Our reference: DOC15/294009

Public Exhibition - Energy from Waste Proposal, Eastern Creek - SSD-6236

ATTACHMENT A – SUMMARY COMMENTS

Figure 3.1: Breakdown of waste feedstock.

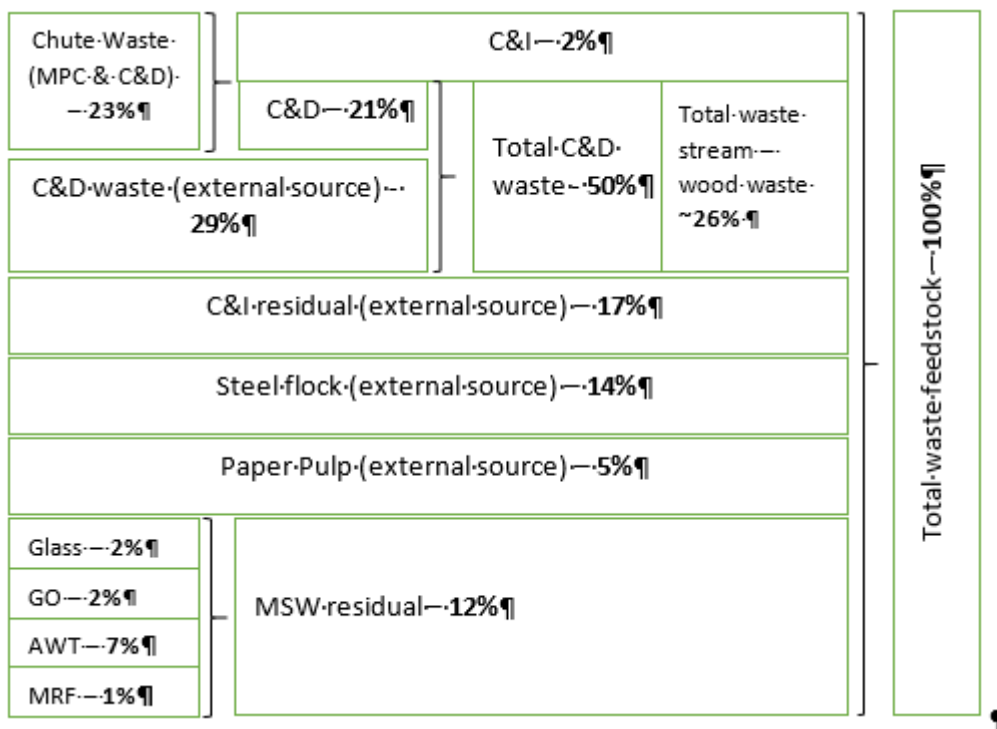
Arup consider that insufficient details have been provided in the EIS to allow a full comparison and assessment of the TNG proposed feedstock in the ratios suggested to the facilities listed in Table 4 – Section 3.5 of the EIS.
